RE: HCPS Roye-Williams Elementary School – HVAC Systemic / Plumbing Renovation (CAG 20-1)

**ADDENDUM 1**  
FEBRUARY 24, 2020

HVAC SYSTEMIC / PLUMBING  
RENOVATION  
ROYE-WILLIAMS  
ELEMENTARY SCHOOL

DRAWING NO:  
**E304A**

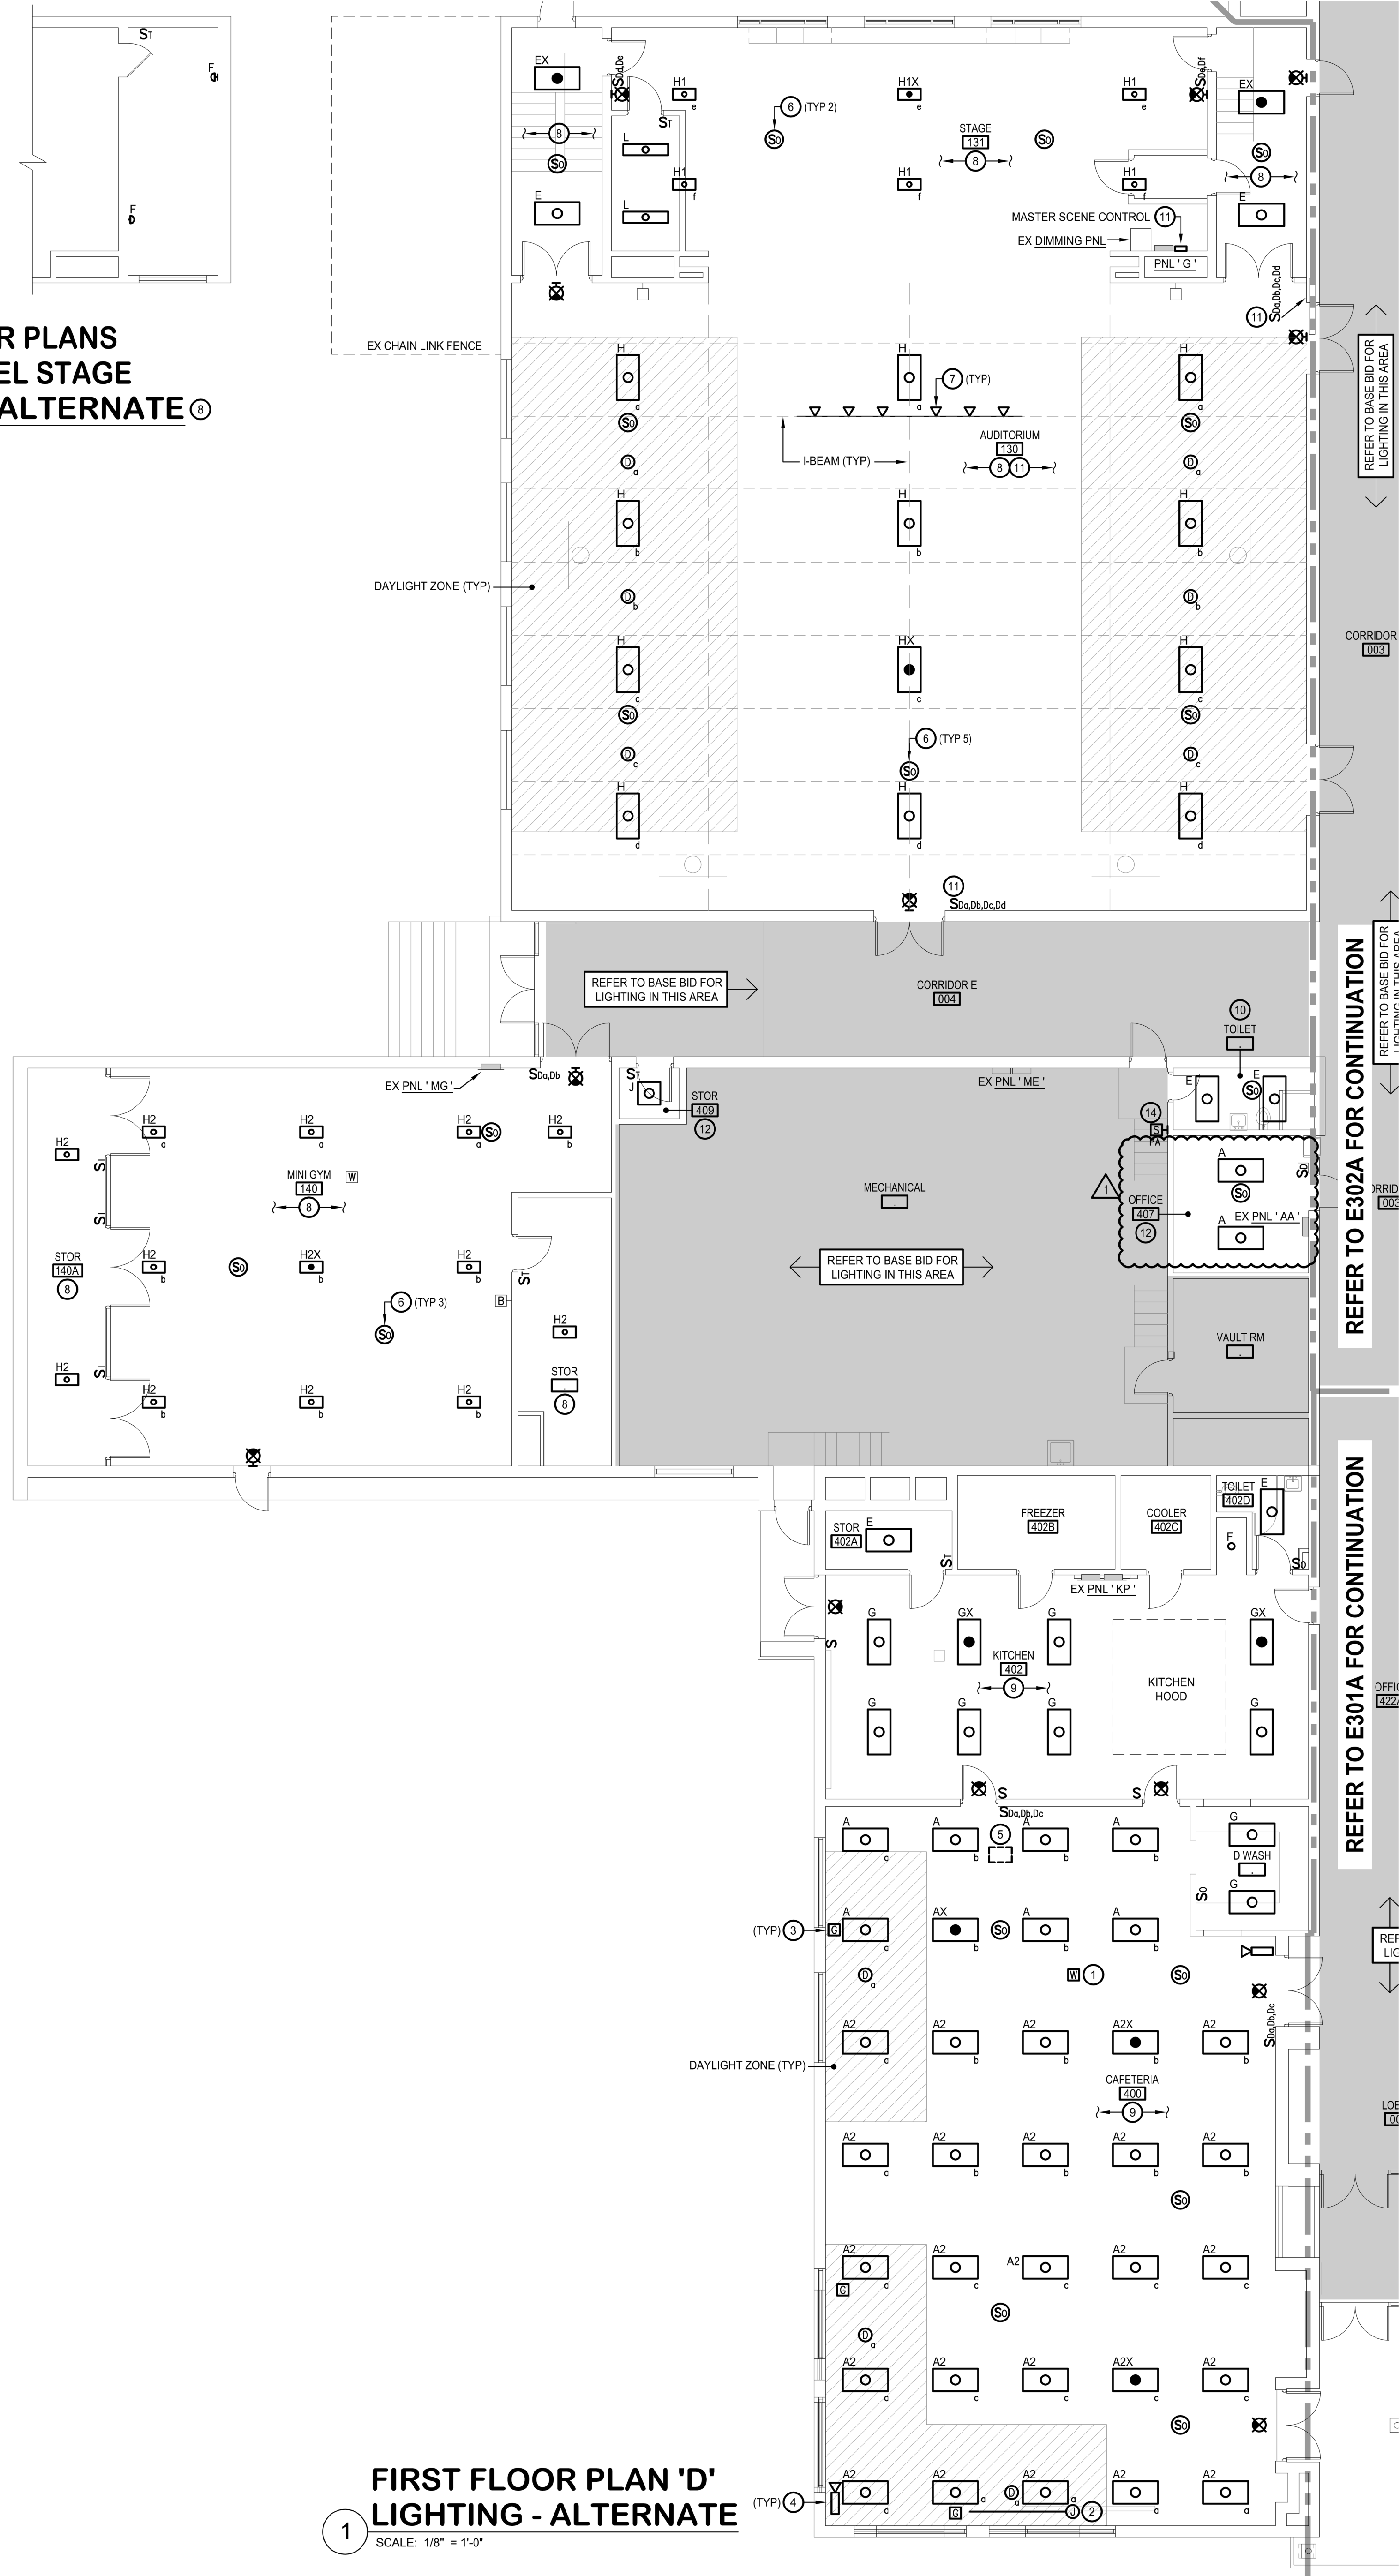
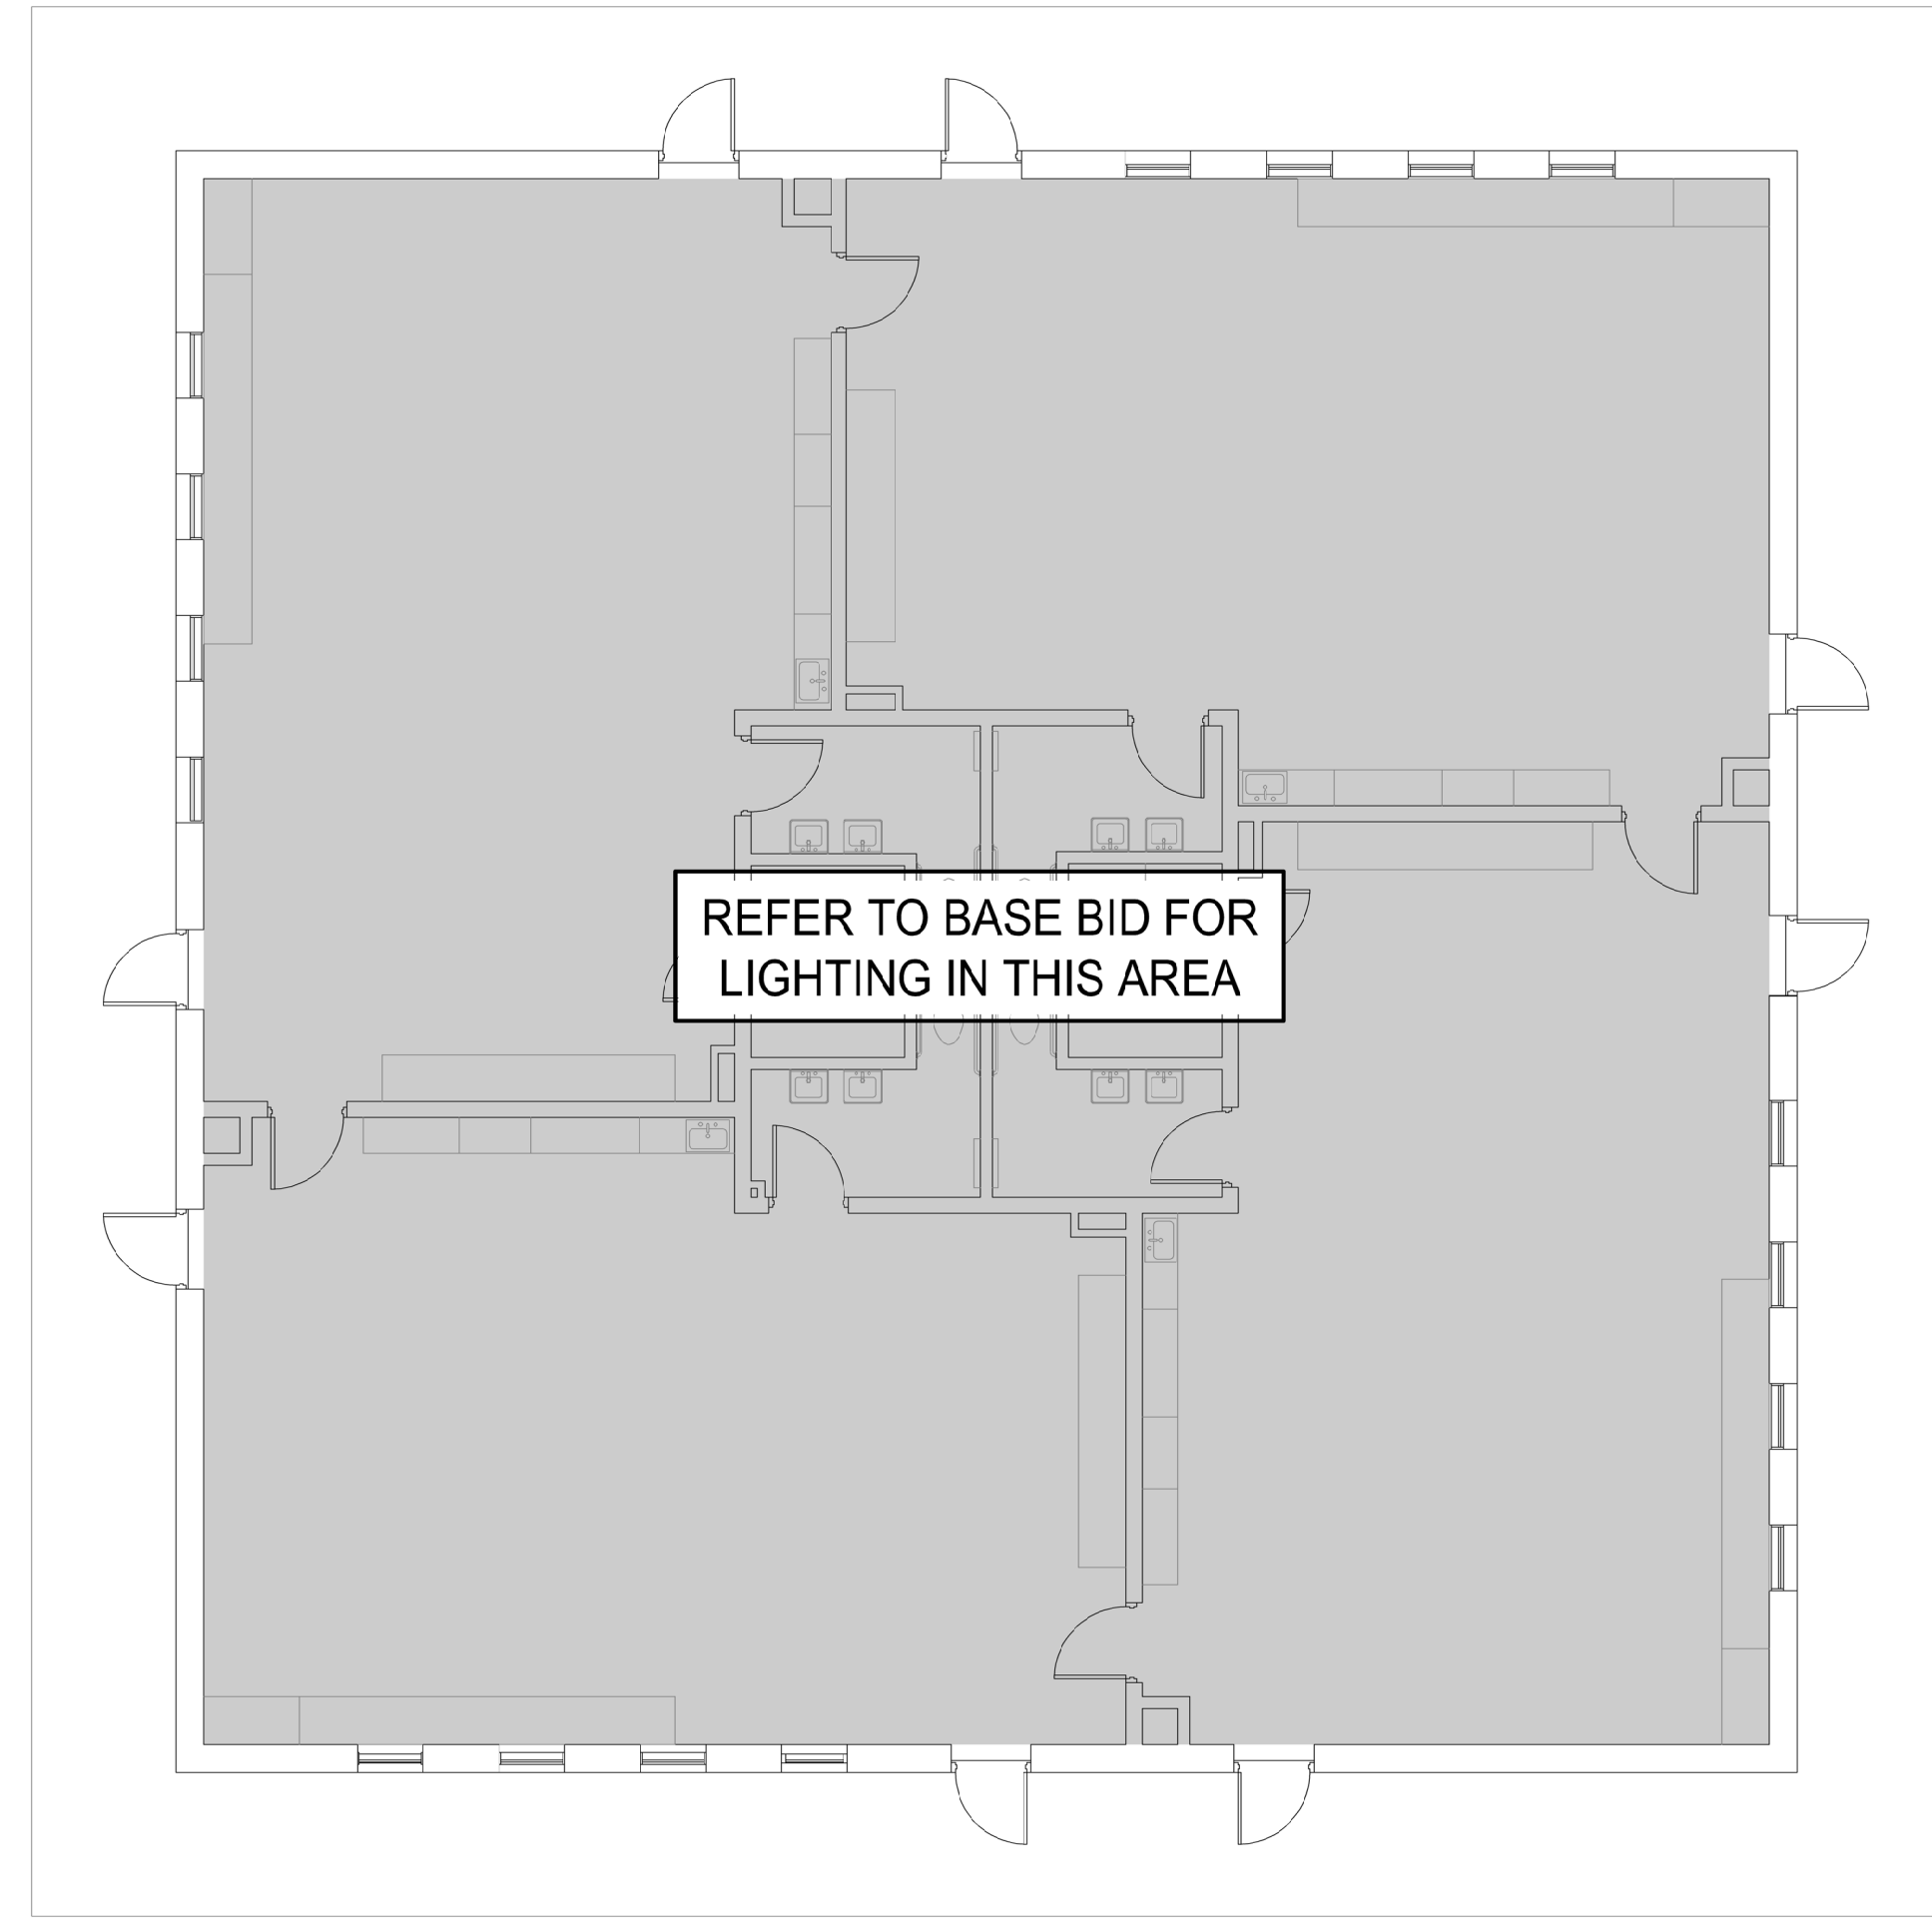
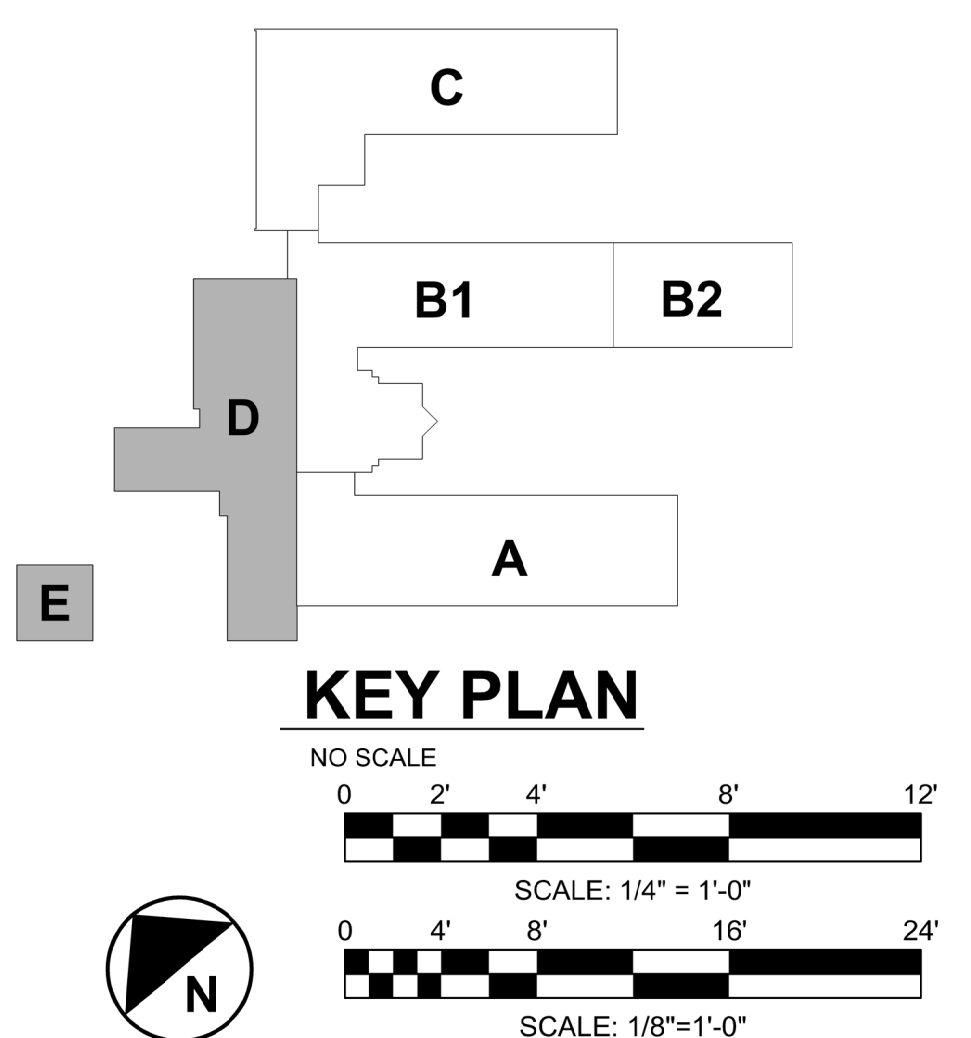
- E302: Corridor PA Speakers: Revise Drawing Note designation from 3 to 11.
- E304A: Replace previously issued drawing with the attached.
- E401A: Kindergarten Building Typical Classroom: Revise switch controlling three Type A lighting fixtures closest to smart board to sub letter a.
